大阪港の航路が変わります。

阪神港(大阪区)

We plan to change The Passage of OSAKA Port.

HANSHIN Port (OSAKA district)

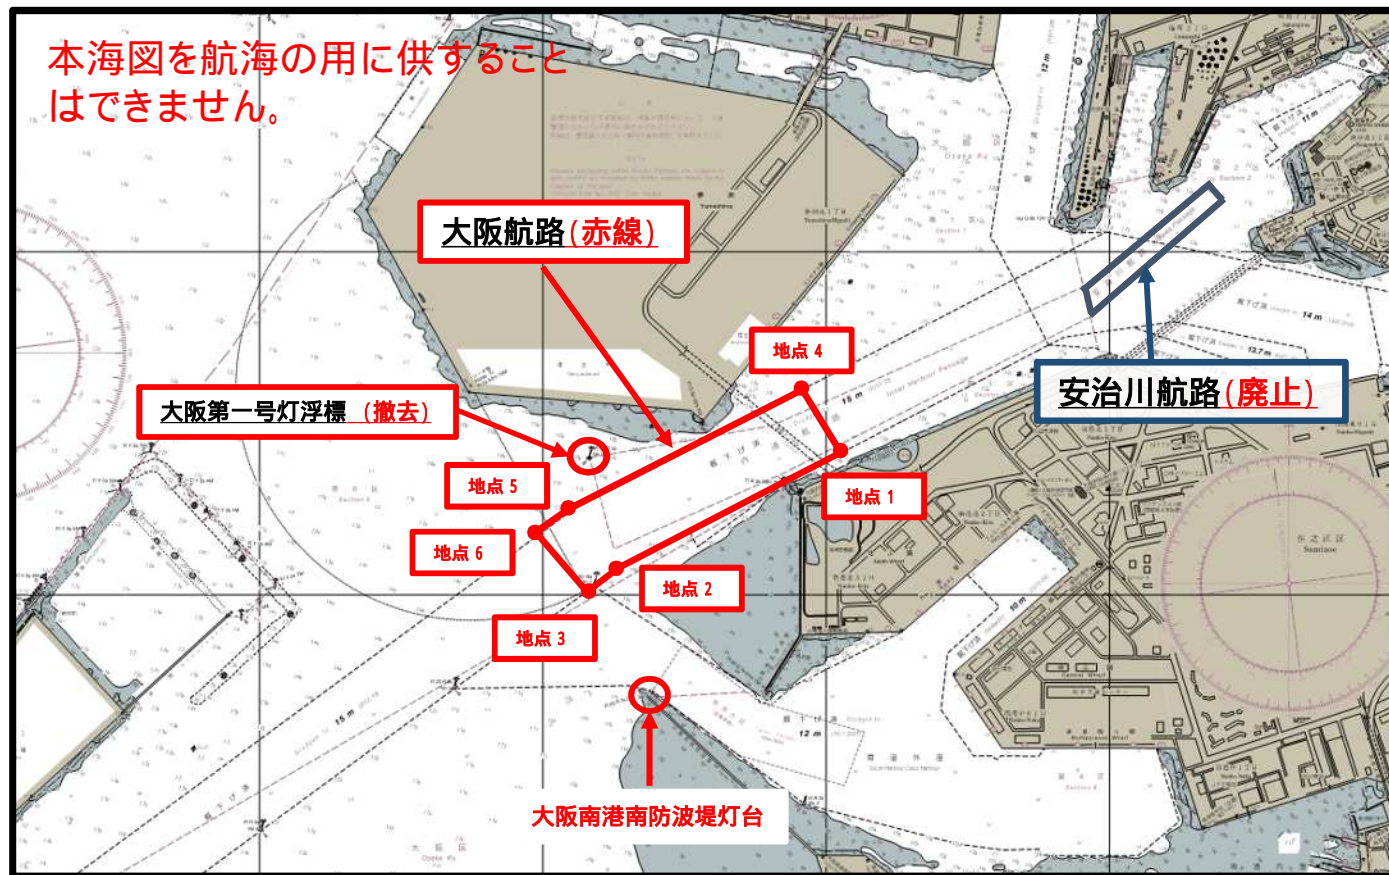
- 1 . 内港航路の形状を変更し名称を**大阪航路**に変更します。(平成31年4月1日)
- 2 . **安治川航路**を廃止します。(平成31年4月1日)
- 3 . **大阪第一号灯浮標**が撤去されました。(平成31年3月8日)

- 1 . We plan to rename “ Osaka Passage ” from “ Inner Harbour Passage ” and change the form of this passage (On April 1, 2019)
- 2 . We plan to abolish Ajikawa Passage (On April 1, 2019)
- 3 . We removed Osaka No1 Light Buoy (On March 8, 2019)

大阪航路の区域(詳細)

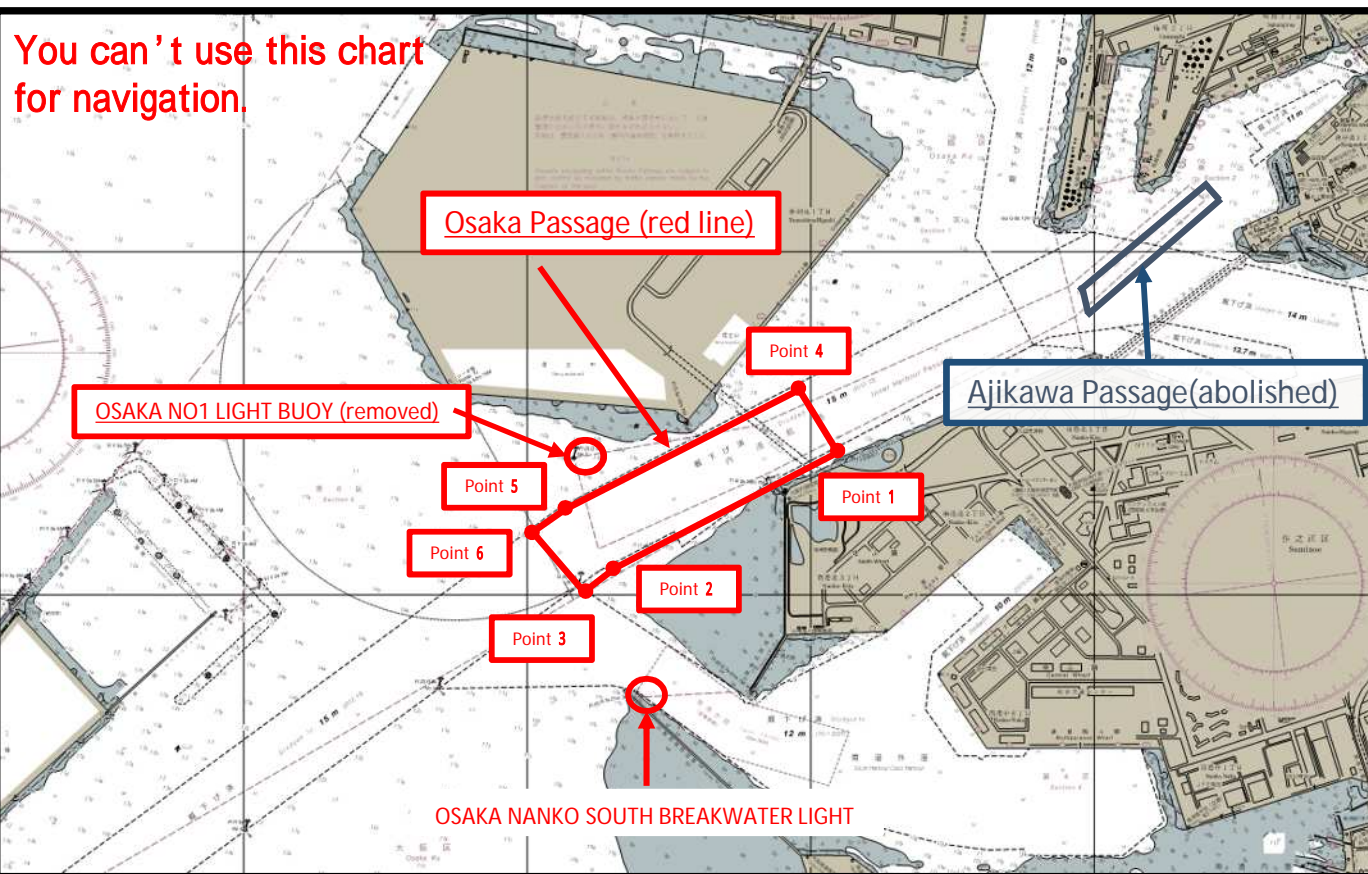
- 第一号の地点から第三号の地点までを順次に結んだ線と第四号の地点から第六号の地点までを順次に結んだ線との間の海面
- 一 大阪南港南防波堤灯台から
三十九度千七百二十メートルの地点
 - 二 大阪南港南防波堤灯台から
三百四十五度三十分七百十メートルの地点
 - 三 大阪南港南防波堤灯台から
三百三十四度六百七十メートルの地点
 - 四 大阪南港南防波堤灯台から
二十八度千九百二十メートルの地点
 - 五 大阪南港南防波堤灯台から
三百三十九度千百メートルの地点
 - 六 大阪南港南防波堤灯台から
三百三十度千六十メートルの地点

- 1 Position 39 degrees, 1,720 meters from the OSAKA NANKO SOUTH BREAKWATER LIGHT
- 2 Position 345 degrees 30 minutes, 710 meters from OSAKA NANKO SOUTH BREAKWATER LIGHT
- 3 Position 334 degrees, 670 meters from OSAKA NANKO SOUTH BREAKWATER LIGHT
- 4 Position 28 degrees, 1,920 meters from OSAKA NANKO SOUTH BREAKWATER LIGHT
- 5 Position 339 degrees, 1,100 meters from OSAKA NANKO SOUTH BREAKWATER LIGHT
- 6 Position 330 degrees, 1,060 meters from OSAKA NANKO SOUTH BREAKWATER LIGHT
